SERVICE BULLETIN

APPLICABILITY: 2020-23MY Outback NUMBER: 03-91-23

SUBJECT: Clicking/Cracking-Type Sound on Slow Turns

Front Drive Axle Shaft - Design Change

DESCRIPTION OF DESIGN CHANGE:

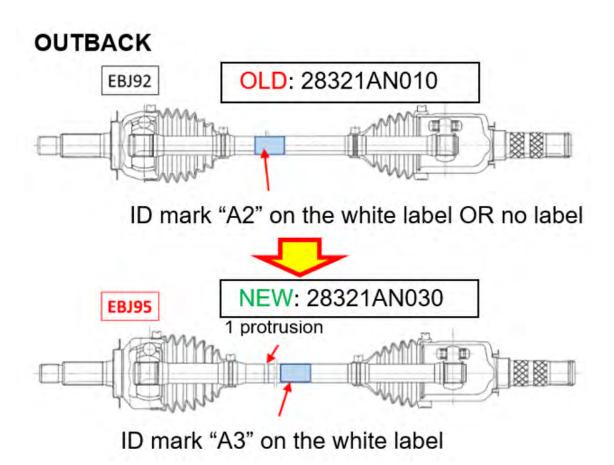
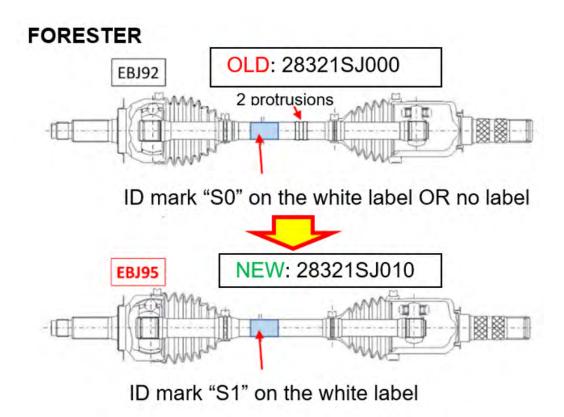
This bulletin announces the design change made to the front drive axle shaft assemblies to address cases of a clicking/cracking-type sound heard when driving with the steering wheel in the fully locked (left or right) position. Size of the joint has been increased to provide added durability. If a clicking/cracking-type sound is duplicated while driving the vehicle with the steering wheel in the fully locked position, replaced the affected side with the newly designed drive axle shaft assembly. The assemblies are not required to be replaced in pairs.

Model	Part Description	Part Number
OUTBACK	DRIVE SHAFT ASSEMBLY-FRONT	28321AN030
FORESTER	DRIVE SHAFT ASSEMBLY-FRONT	28321SJ010
OUTBACK & FORESTER	NUT (One Time Use)	902170049
